ADDENDUM

PROJECT: Forestside Estates
Attmar & Palleschi Drive
Brampton, Ontario

ADDENDUM NO. E-2

PURPOSE: To suit architecture, sprinkler system changes and Mech Addendum M-4.

3RD FLOOR LOBBY ENTRANCE BUILDING C AND D

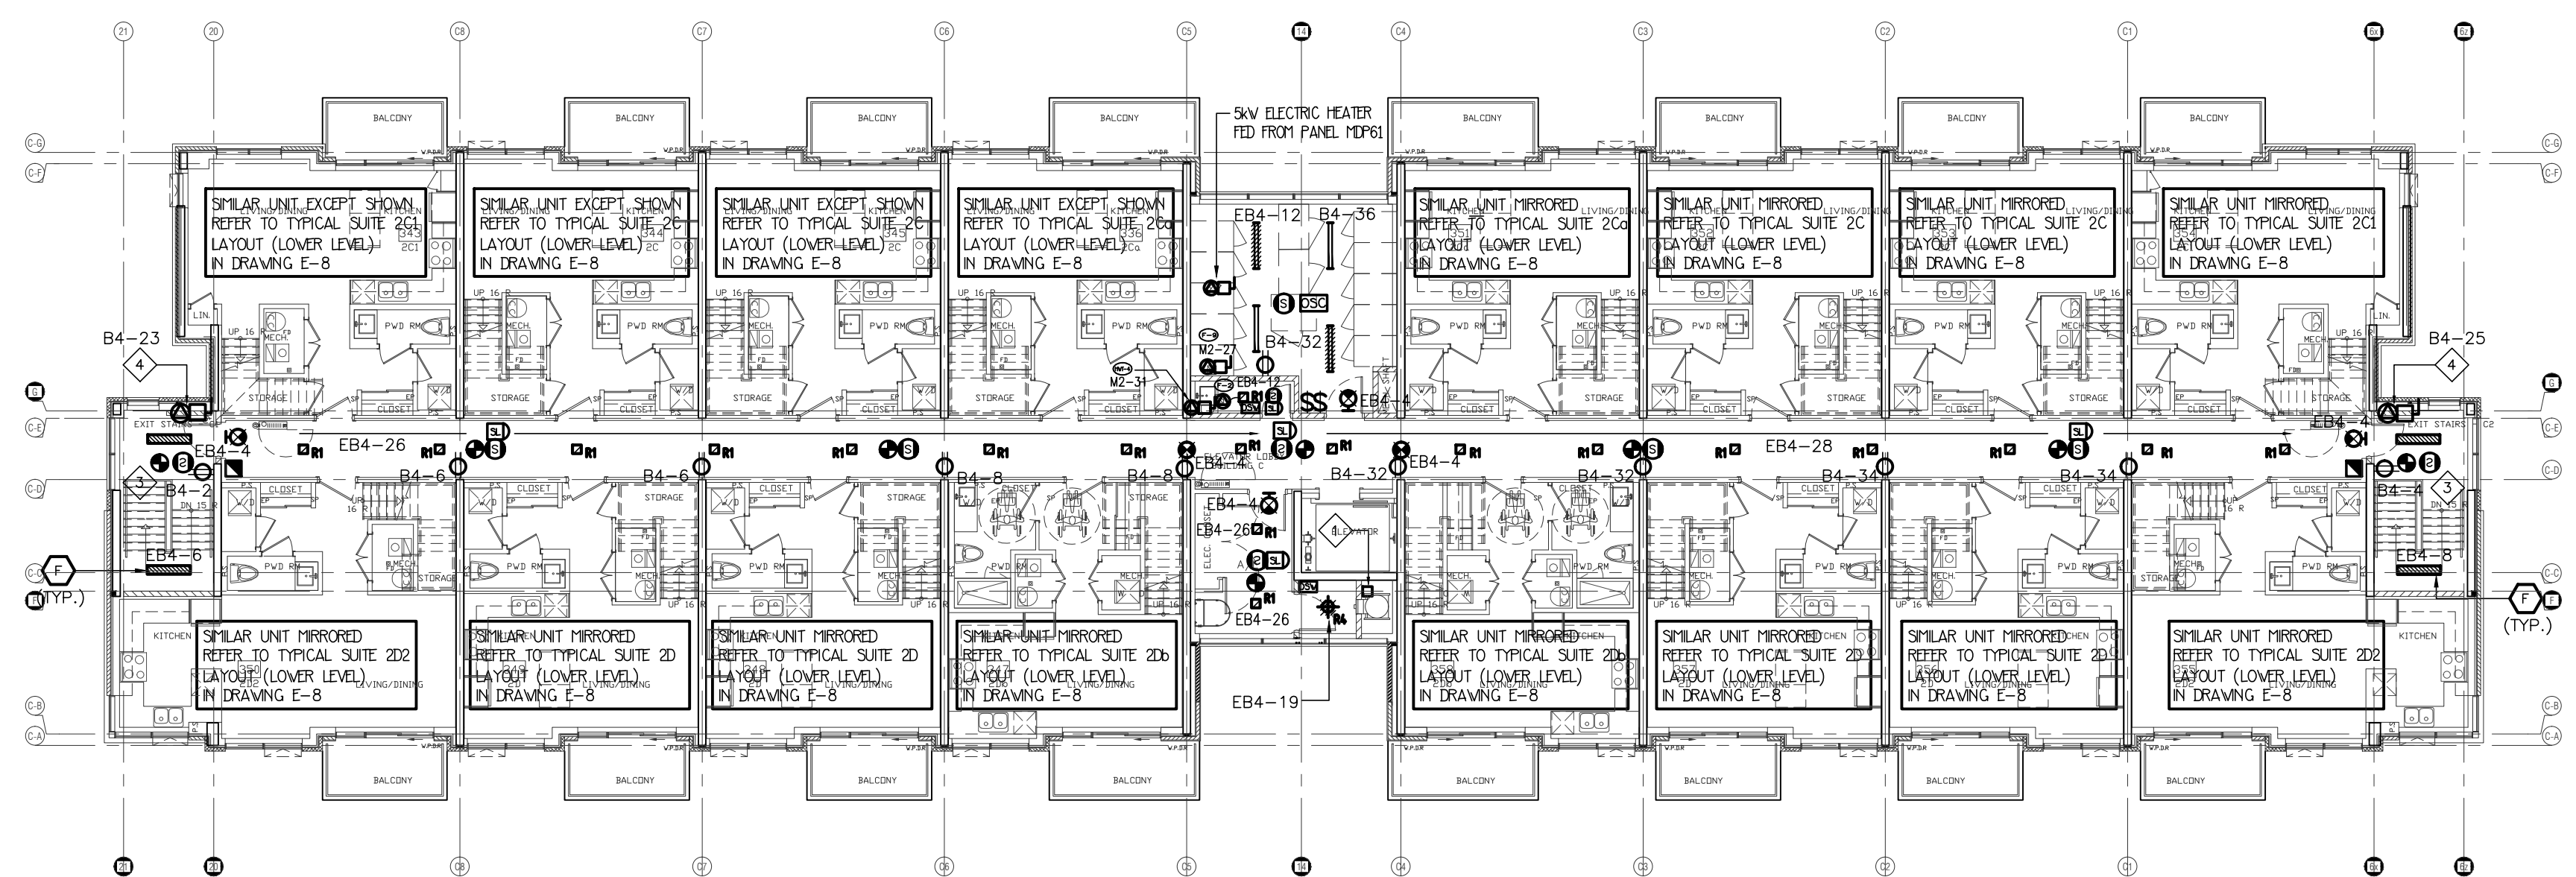
3.1 Revise: Electrical layout to suit latest arch drawings as shown

TITLE FIRE ALARM SYSTEM ELECTRICAL			
PROJECT BRAMPTON STACKED FORESTSIDE ESTATES			
ATTMAR + PALLESCHI DRIVE BRAMPTON, ONTARIO			
DRAWN BY DATE MAY, 2019	CHECKED MG PROJECT 18-017	SCALE NTS	DRAWING E-11
	OF		16

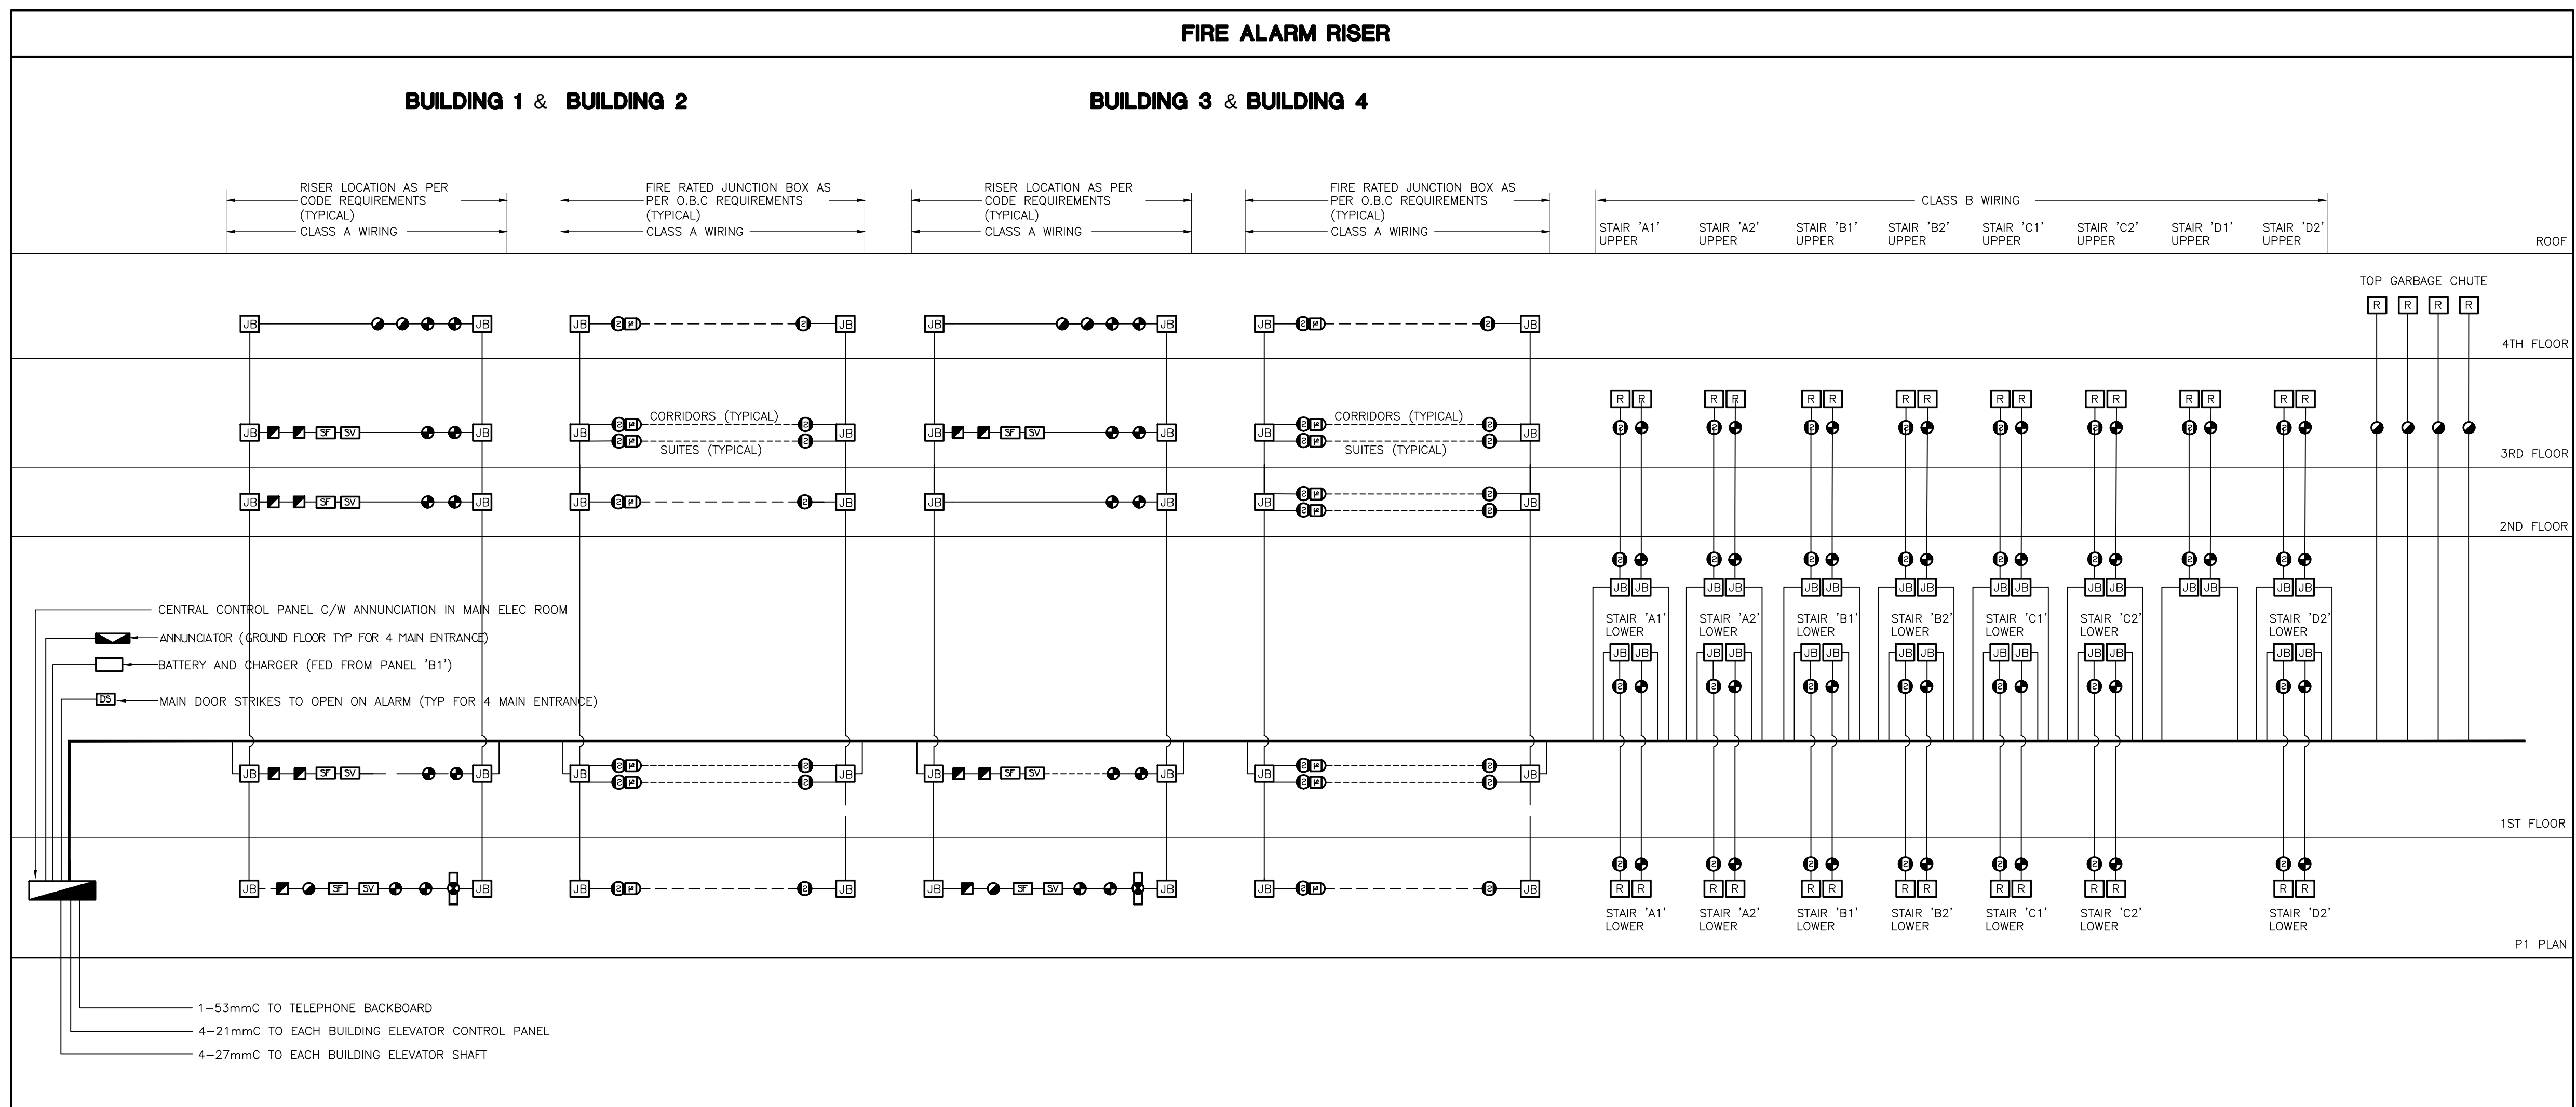
7.1 Revise: Fire alarm schedule as shown.
